TYPE NO FB7300	TYPE Coffe Vending Machines	T.I. NO 2013_03				
SERIAL NUMBERS AFFECTED From and including S/N 24011223	ISSUED BY Documentation/N&W Valbrembo					
SUBJECT TASTE IMPROVEMENT		ISSUED FOR (X): <table border="1"> <tr> <td>Action</td> <td></td> </tr> <tr> <td>Information</td> <td>X</td> </tr> </table>	Action		Information	X
Action						
Information	X

- In order to improve the taste of the machine's beverage, the material of the waste bucket has been change and the insulator of the boiler has been removed.

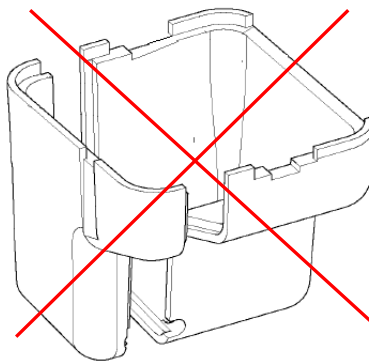
- The material of the waste bucket has been changed from ABS to self-extinguishing polystyrene
- The boiler insulator **39759100** has been removed and a support boiler (**256518**) + gasket (**099844**) have been introduced in order to maintain the boiler in the right position
